From: "Craig Caplick - NEON" <Craig@consultneon.com.au>
Sent: Thu, 28 May 2026 11:20:01 +1000
To: "Dee Petersen" <deep@msc.qld.gov.au>
Cc: "Carl Ewin" <CarlE@msc.qld.gov.au>; "Brian Millard" <BrianM@msc.qld.gov.au>
Subject: RE: Request for Operational Works Application Information Confirmation -
Amaroo Stage 15
Attachments: 048-2501-15-Amaroo Stage 15_260528_Add Lot 360.pdf

AMAROO ESTATE SUBDIVISION, MAREEBA

STAGE 15

AMAROO ESTATE SUBDIVISION
 STAGE 15
 SITE BASED STORMWATER MANAGEMENT PLAN
 PHASE 2: EARTHWORKS

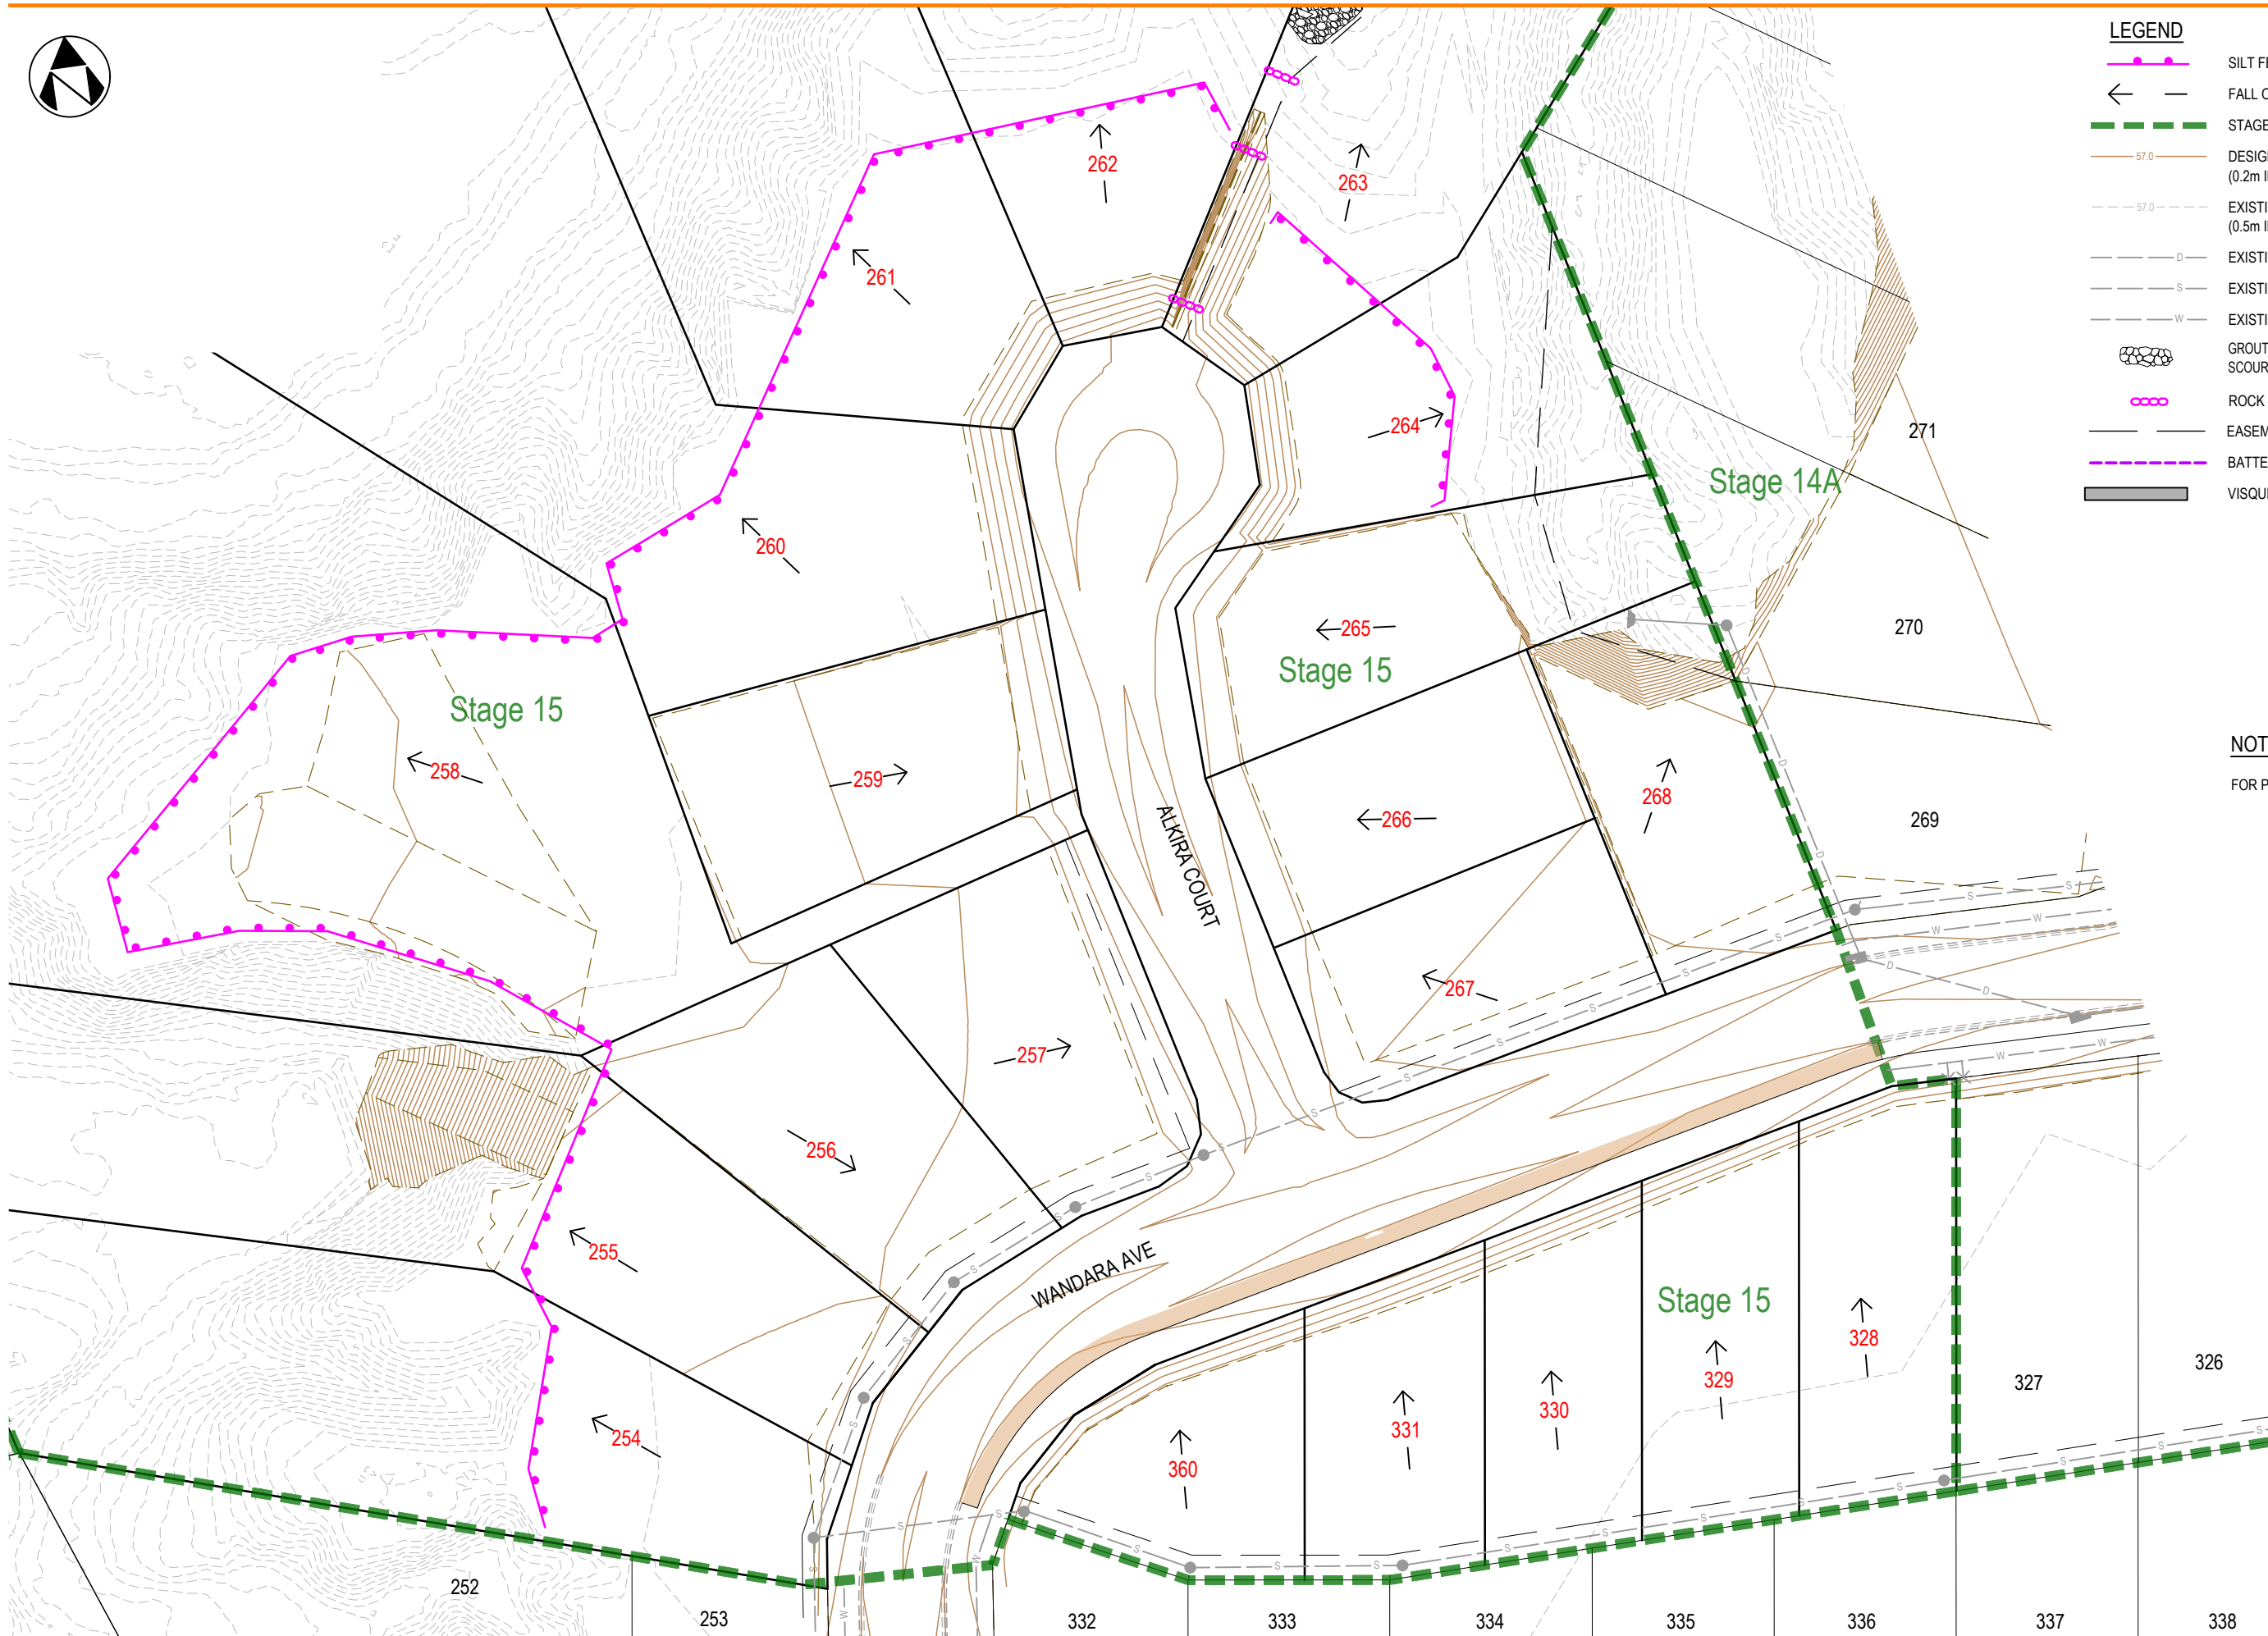
Rev B 28.05.26 ADDITIONAL LOT 360 ADDED
 Rev A 30.10.25 INITIAL ISSUE

AMAROO ESTATE SUBDIVISION
 STAGE 15
 SITE BASED STORMWATER MANAGEMENT PLAN
 PHASE 3: ROADWORKS

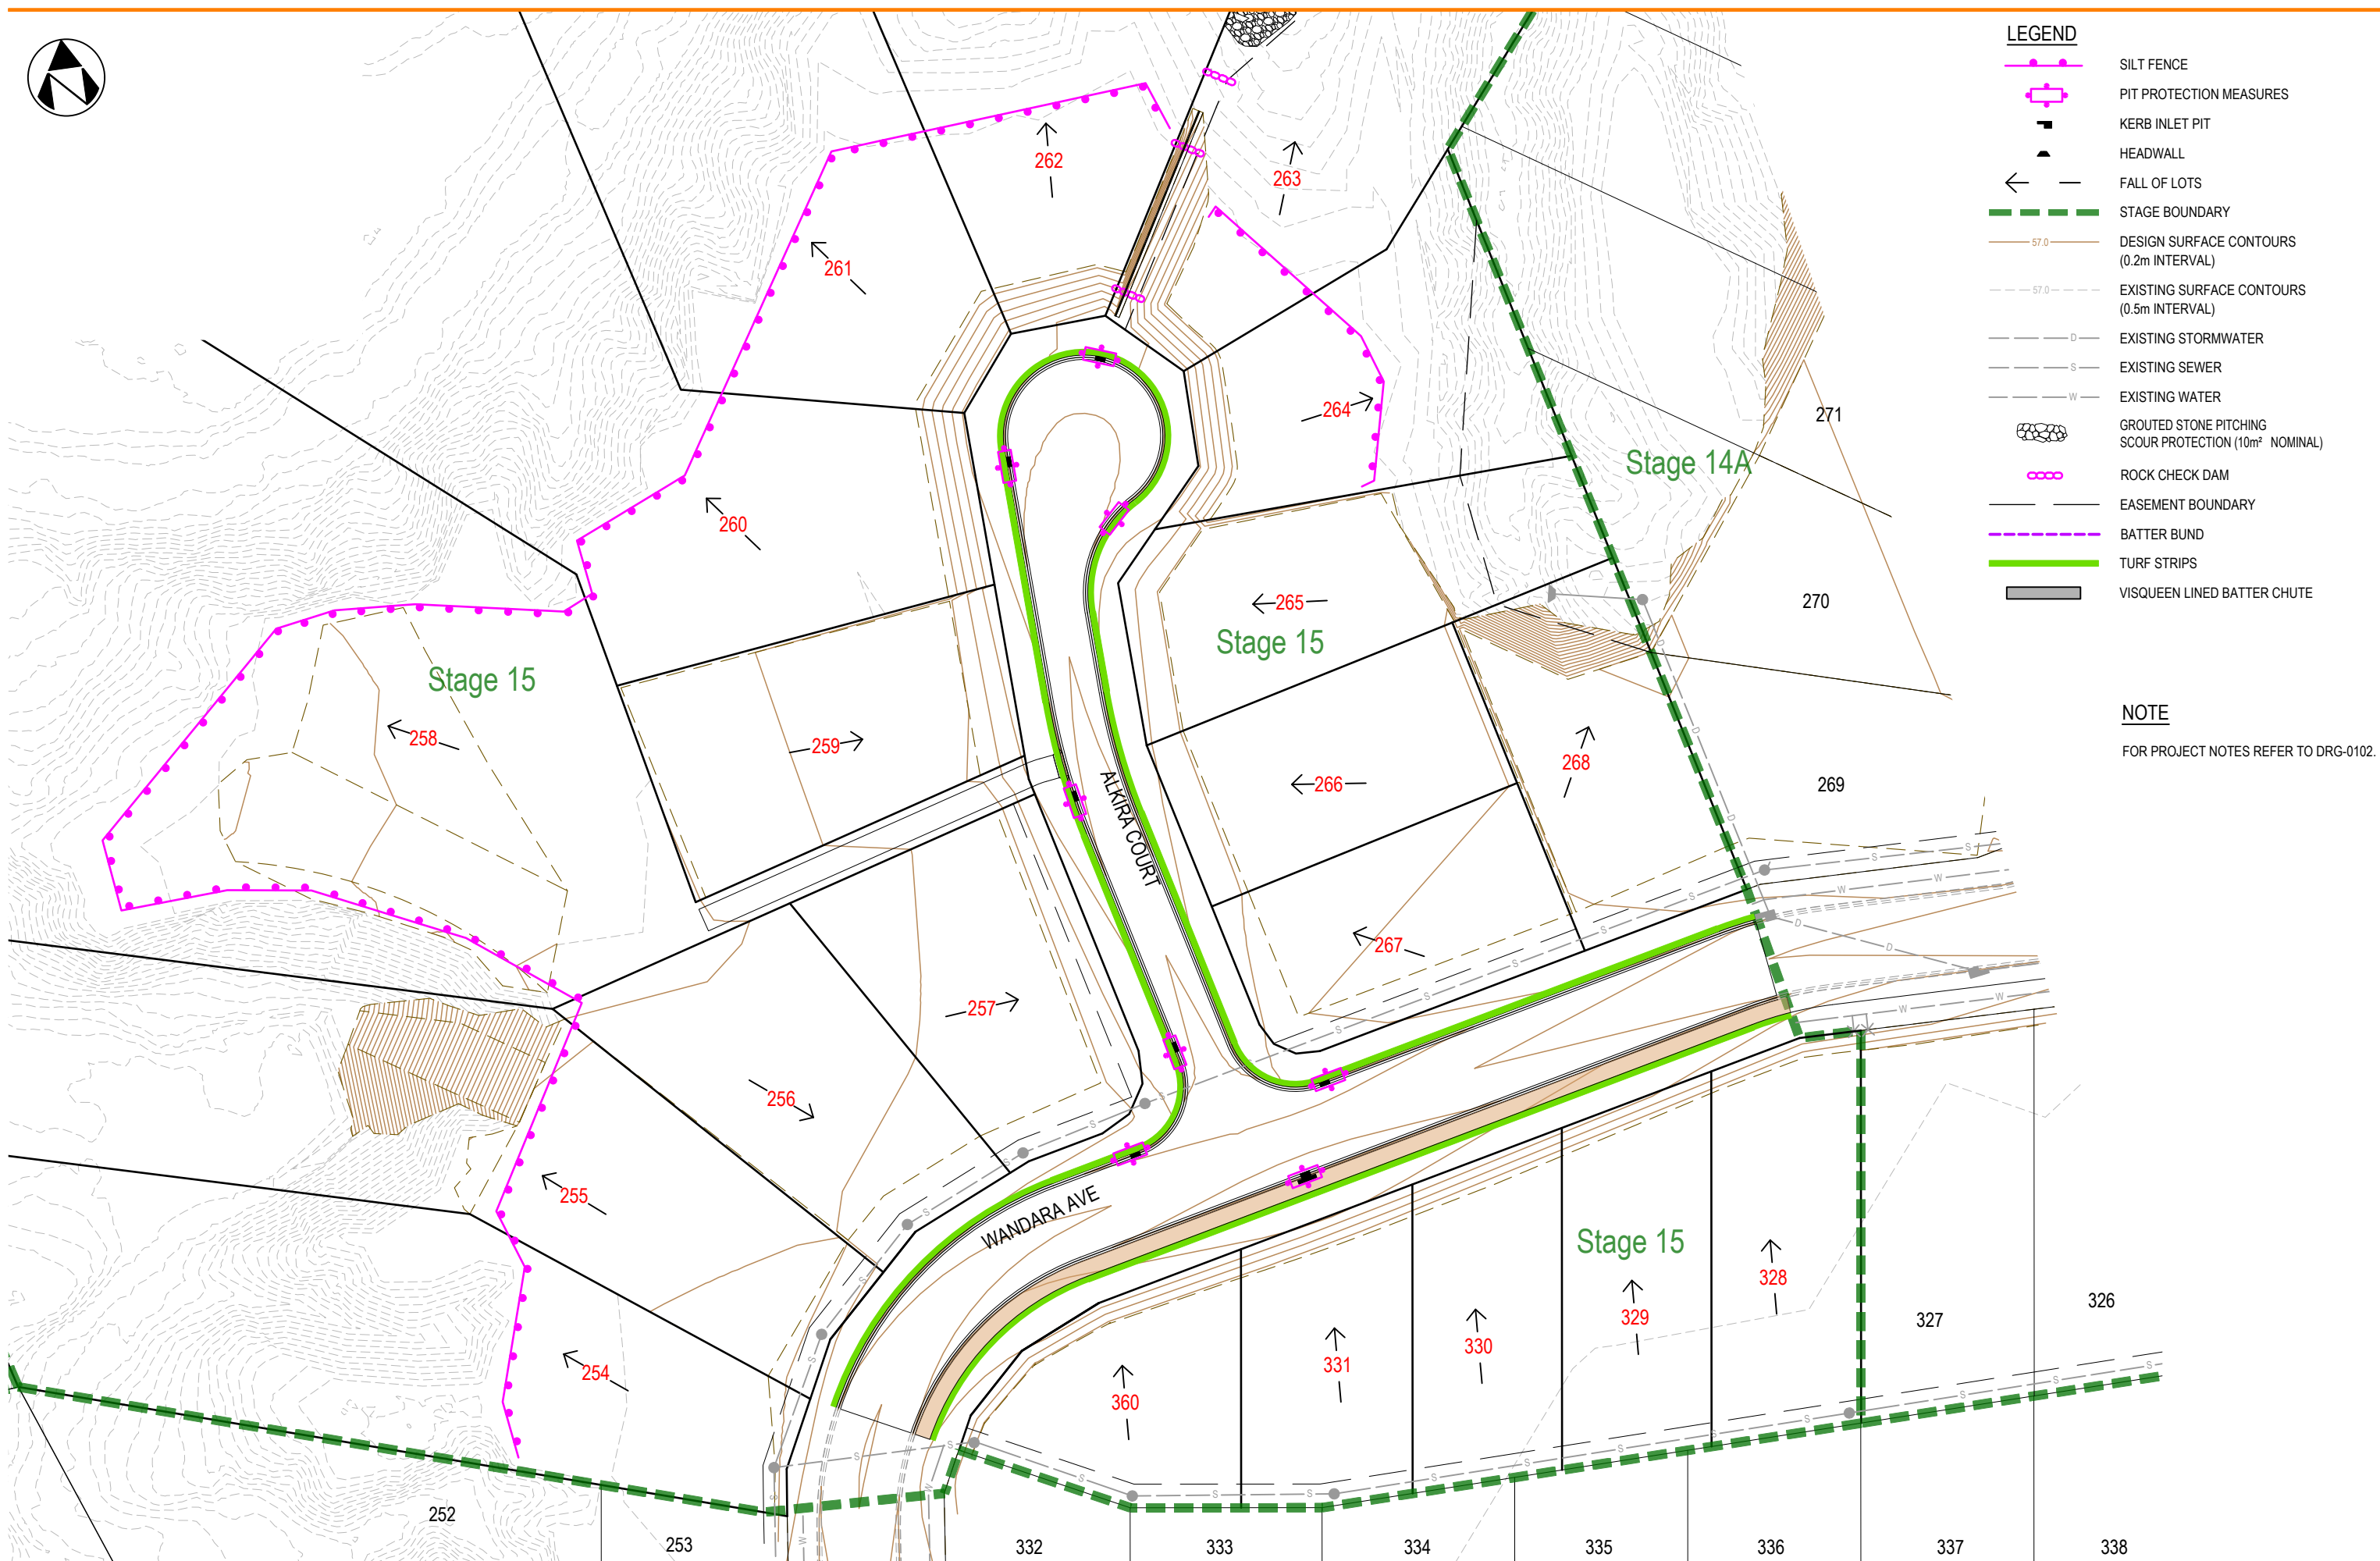
Rev	Date	Revision Notes
C	28.05.26	ADDITIONAL LOT 360 ADDED
B	23.12.25	STORMWATER REVISED
A	30.10.25	INITIAL ISSUE

AMAROO ESTATE SUBDIVISION
STAGE 15
MASTER SERVICES PLAN

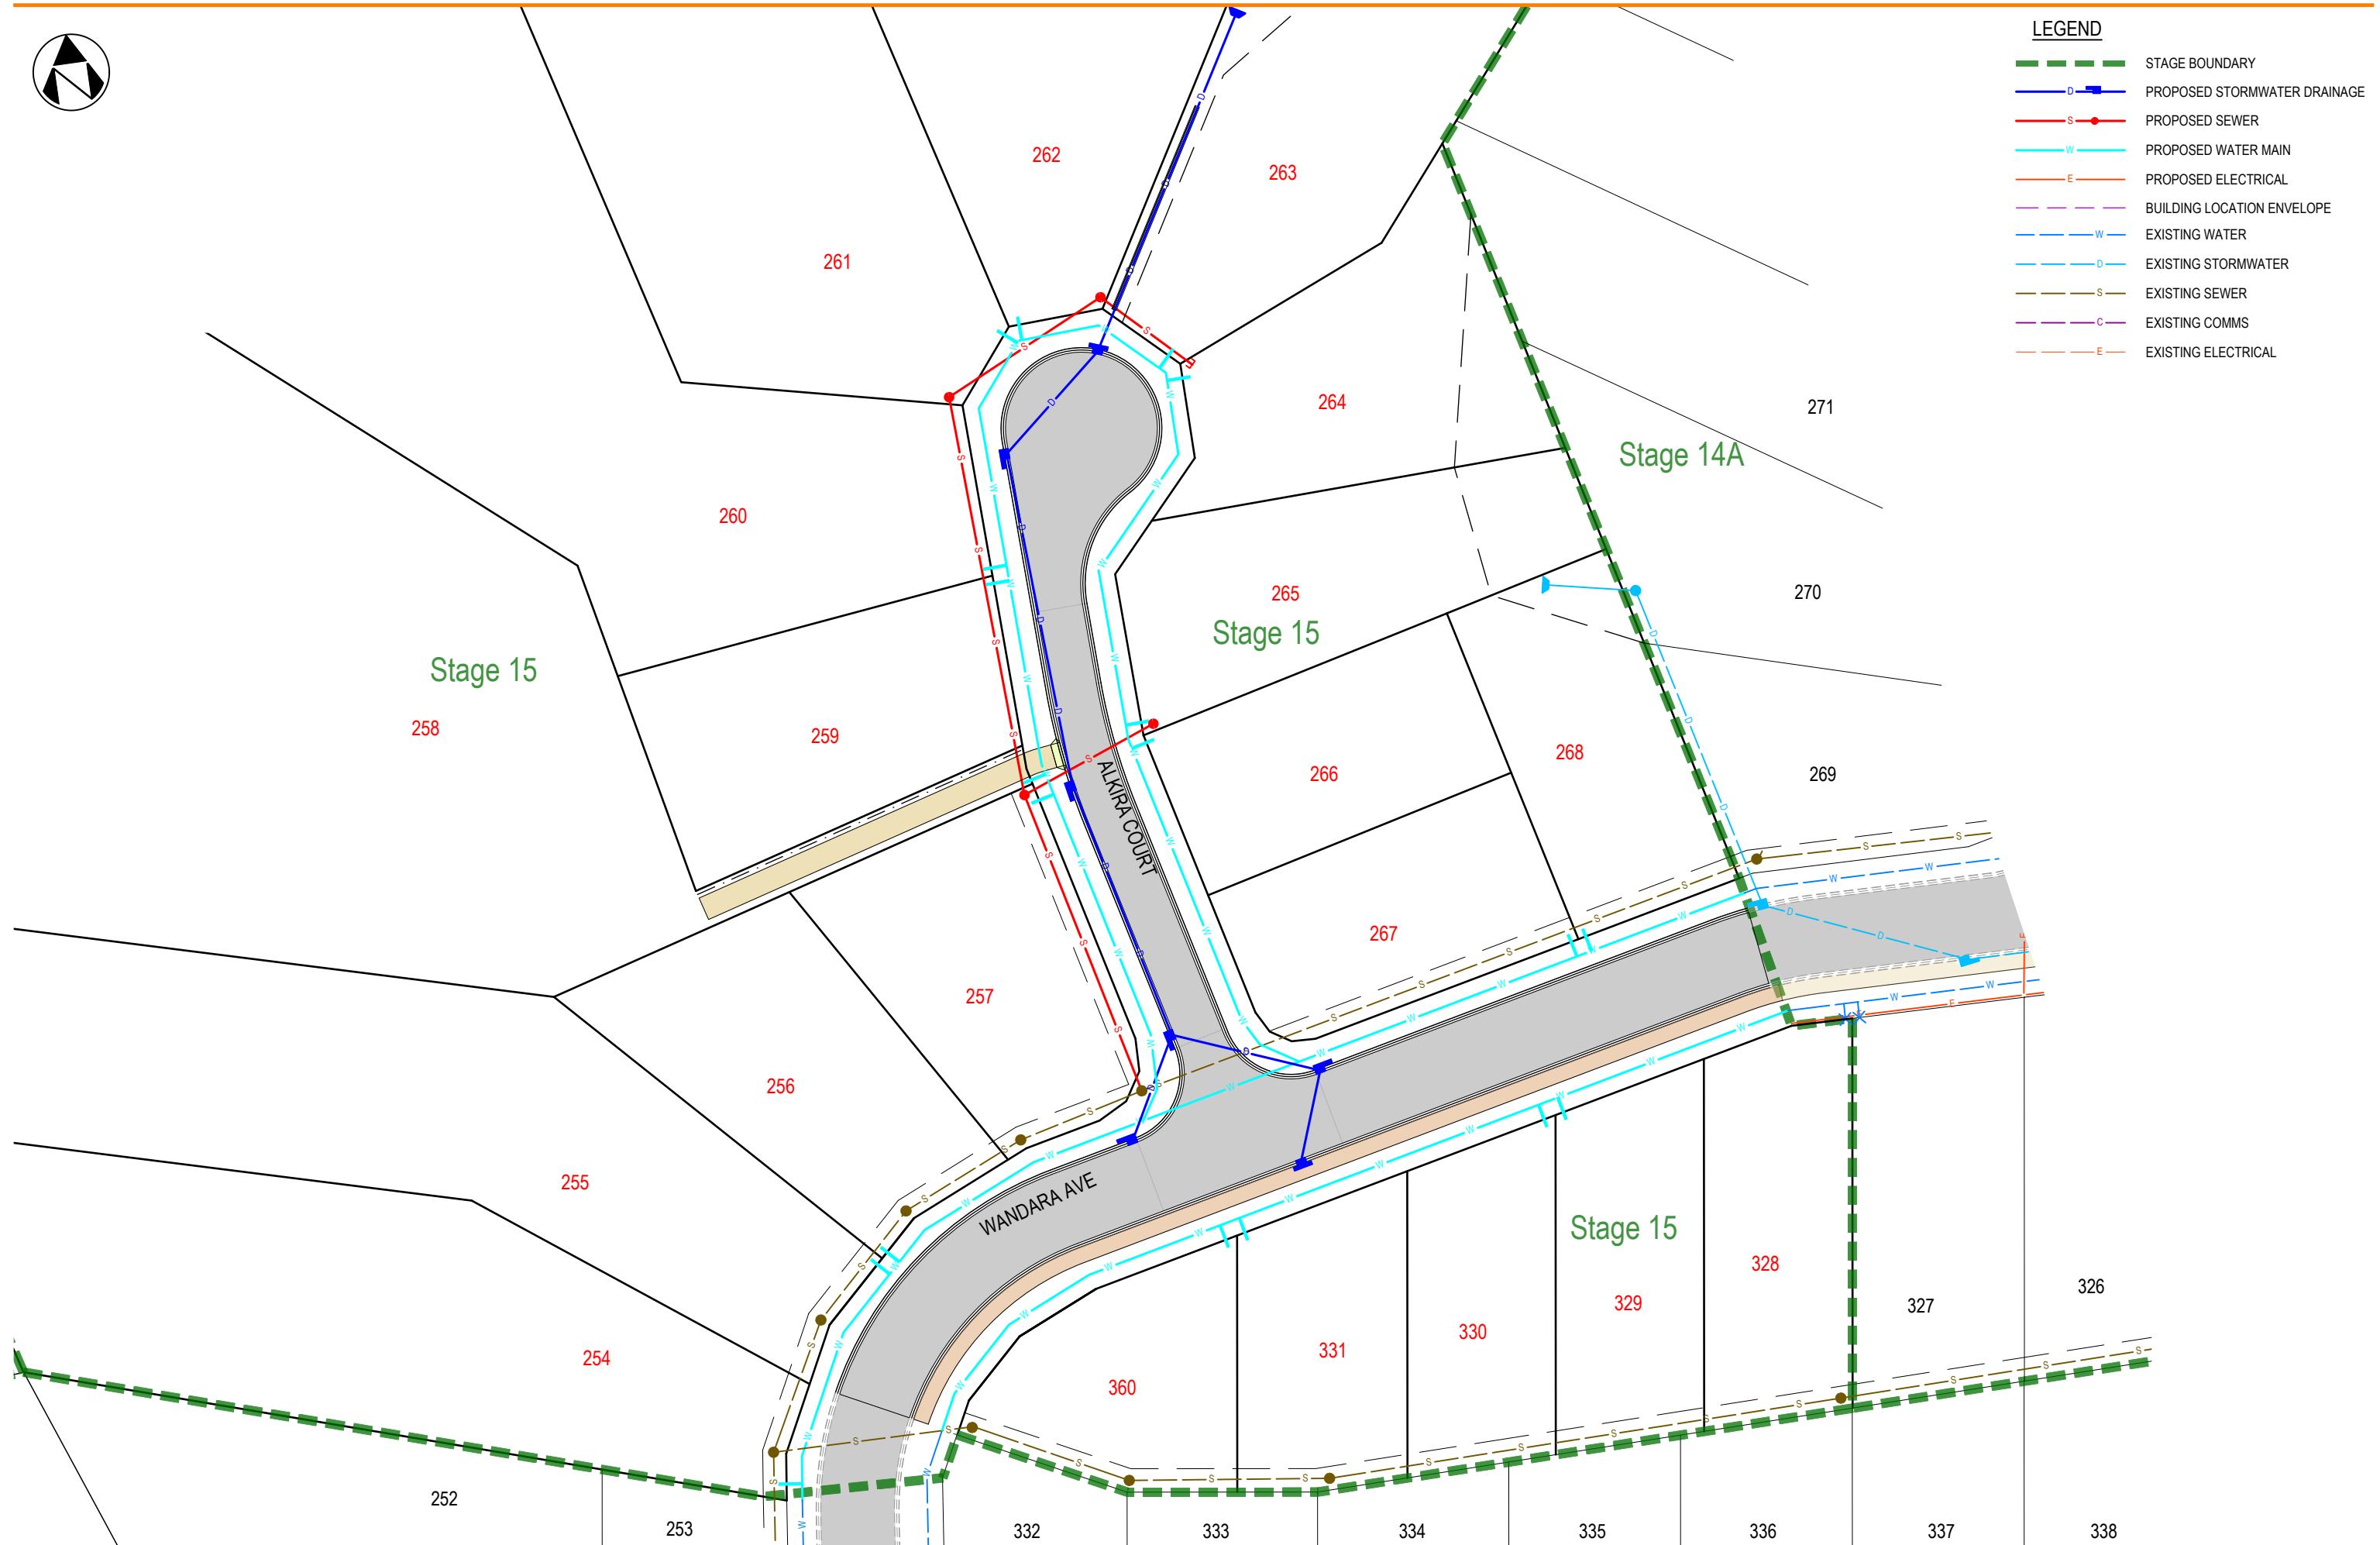
Rev	Date	Revision Notes
C	28.05.26	ADDITIONAL LOT 360 ADDED
B	23.12.25	STORMWATER REVISED
A	30.10.25	INITIAL ISSUE
